FAQ Title NFPA 805 MonitoringPlant: Harris Nuclear PlantDate: October 10, 2016Contact: Jessica WalkerPhone: 479-857-1975Email: jwalker@jensenhughes.com**Distribution:** *(NEI Internal Use)* 805 TF FPWG RATF RIRWG BWROG PWROG**Purpose of FAQ:**

FAQ Number 10-0059

FAQ Revision 6

FAQ Title NFPA 805 Monitoring

Figure E-1 – NFPA 805 Monitoring Process

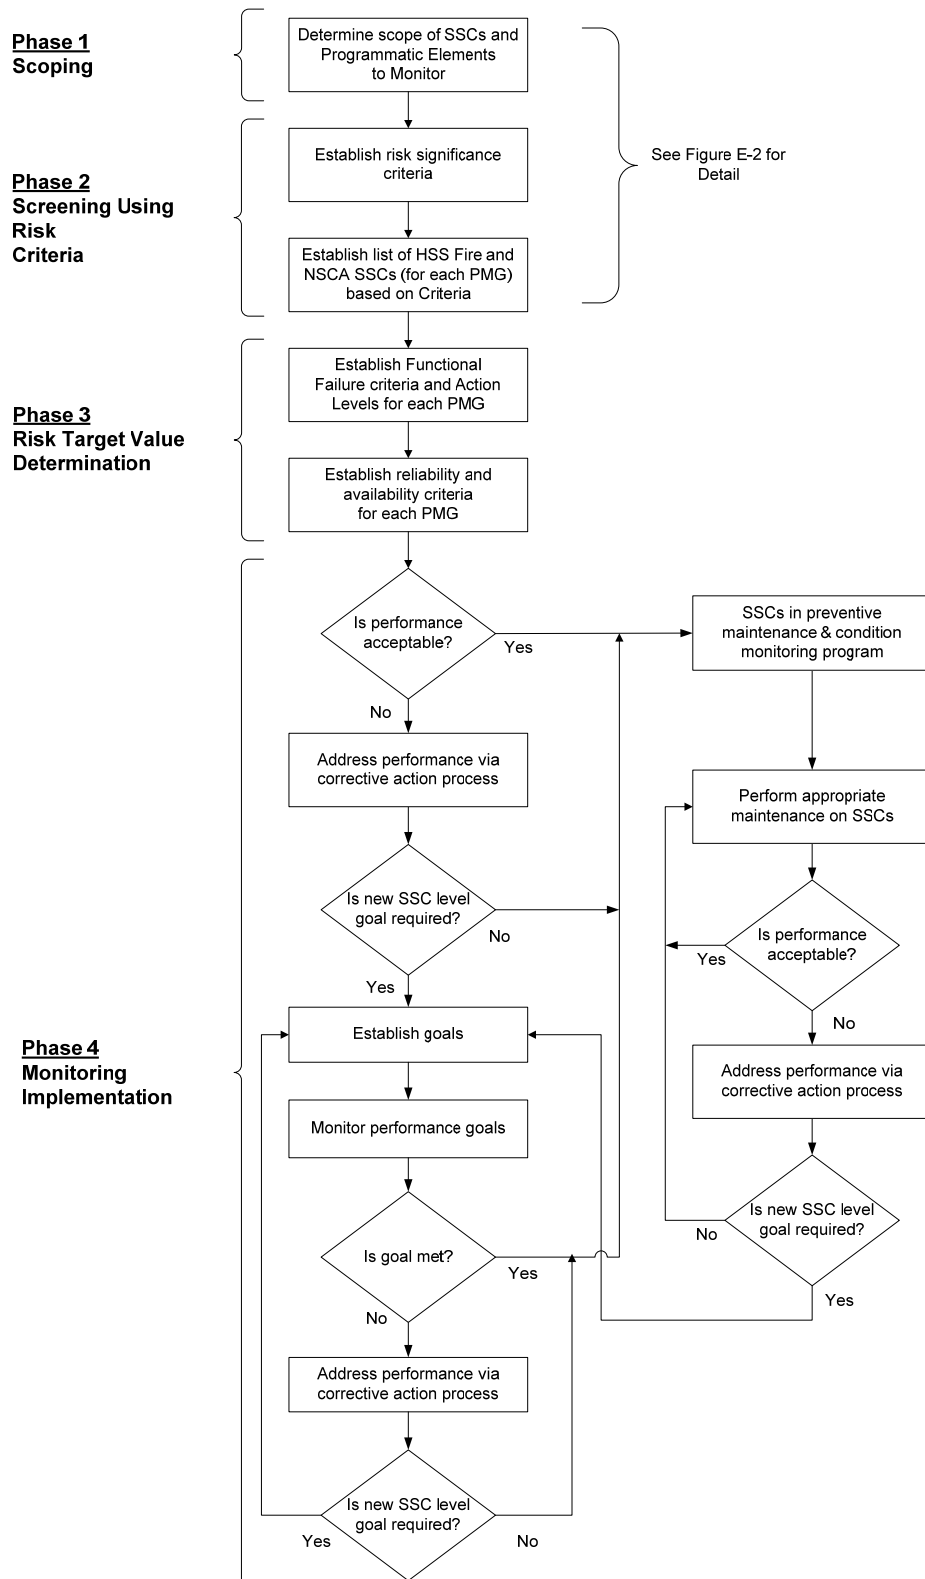
REPLACE ALL OF APPENDIX E WITH THE FOLLOWING:

A suggested methodology is outlined below. Figure E-1 provides an overview of the Monitoring Process, while Figure E-2 provides detail on a process for Phases 1 and 2.
